# Maule Aircraft Corporation

Service letter # 19

Models Affected M-4, M-4-210, M-4-220 S,T, & C  
Serial No's M-4-1T thru 3T, 1C thru 11C, 3 thru 94  
and 1S thru 3S M-4-210 1001 thru 1045, 1001C thru  
1075C and 1079C and 1080C, M-4-220, 2001C thru 2029C and  
2032C, 2001S

SERVICE LETTER #19CONTROL COLUMN ASSY

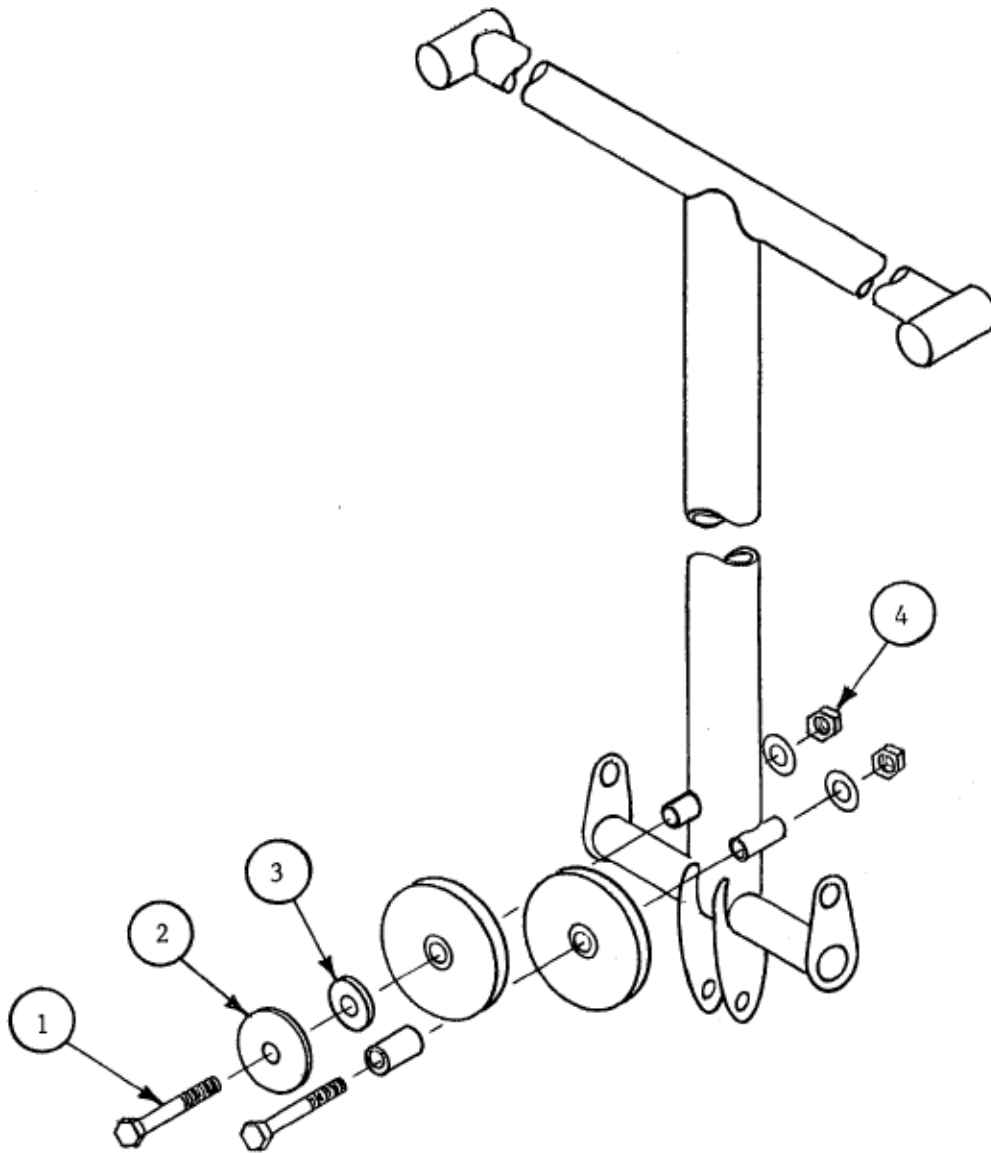
We have discovered a possibility that the pulley on the  
lower control column could come off the pulley bearing if  
the bearing didnot have the proper press fit in the pulley.  
This is a mandatory item and must be complied with at your  
earliest convenience.

REF. NO.	PART NO.	REQ.	DESCRIPTION
1	AN5-27	1	BOLT
2	AN970-5	1	WASHER
3	AN960-516	1	WASHER
4	AN365-524	1	NUT
